Access Compliance Report

Public Rights-of-Way

(Curb Ramps)

Intersection ID: 54365	Main Street: COLLINS_FORD_RD	Cross Street: GANNON_DR	Location: SW
ADA ID: C6906E8A549A	Ramp Type: Perp	Initial Pass/Fail: Fail	Overall Compliance: No
Severity Score: 1.25			
Codes/Mitigation Info/Possible Solution		Field Measurements/Component Compliance

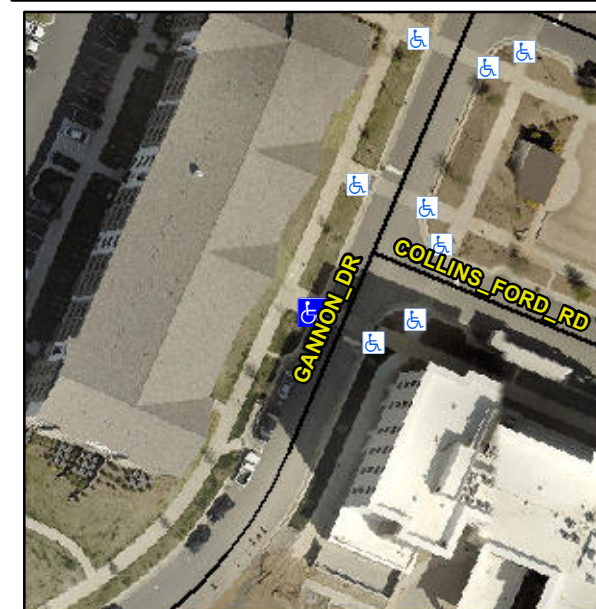
R304.5.3

Compliance	Description	Data	Compliance	Description	Data
N/A	Ramp Length (in)	73.0	Yes	Ramp Slope (%)	7.7
Yes	Ramp Width (in)	95.0	No	Ramp XSlope (%)	2.7
N/A	Flare Type LT	N/A	N/A	Flare Type RT	N/A
N/A	Flare Slope LT (%)	N/A	N/A	Flare Slope RT (%)	N/A
N/A	Flare Traversable LT?	N/A	N/A	Flare Traversable RT?	N/A
N/A	Landing Length (in)	N/A	N/A	DWS Provided?	N/A
N/A	Landing Width (in)	N/A	N/A	DWS Contrast?	N/A
N/A	Landing Slope (%)	N/A	N/A	DWS Length (in)	N/A
N/A	Landing X Slope (%)	N/A	N/A	DWS Full Width?	N/A
N/A	Landing Curb? (Y/N)	N/A	N/A	DWS Offset (in)	N/A
N/A	Shared Landing?	N/A			
N/A	Gutter Ponding?	N/A	N/A	Gutter Slope (%)	N/A
N/A	Gutter Lip Ht (in)	N/A	N/A	Gutter X Slope (%)	N/A
N/A	Painted X Walk1?	Yes	N/A	Painted X Walk2?	N/A
	X Walk 1 Direction	To SE		X Walk 2 Direction	N/A
N/A	X Walk 1 Width (in)	98.0	N/A	X Walk 2 Width (in)	N/A
	X Walk 1 Slope (%)	2.7		X Walk 2 Slope (%)	N/A
	X Walk 1 X Slope (%)	1.7		X Walk 2 X Slope (%)	N/A

Remove & Replace Entire Ramp.
